Access Compliance Report Public Rights-of-Way (Curb Ramps)

Main Street: WINFIELD_DR Cross Street: O_NEILL_DR Location: NE

ADA ID: RPRK211025122649 Ramp Type: Type 1 - Perpendicular Diagonal Initial Pass/Fail: Fail Overall Compliance: No Severity Score: 15

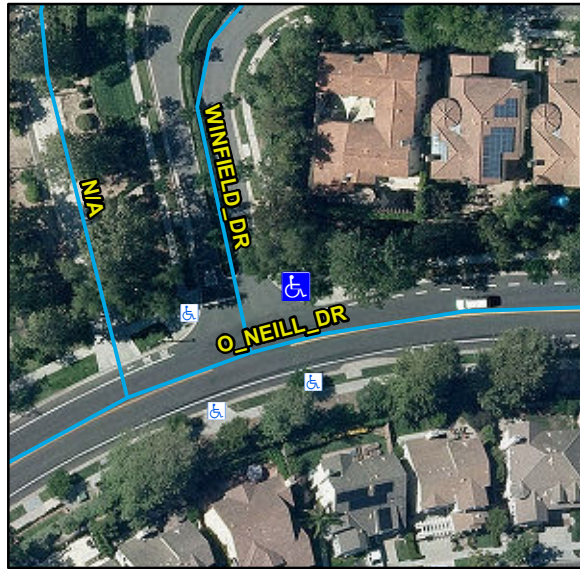
R204.3, R304.2.2, STD 1115

Remove & Replace Curb Ramp With Two New Directional Ramps or Equivalent.
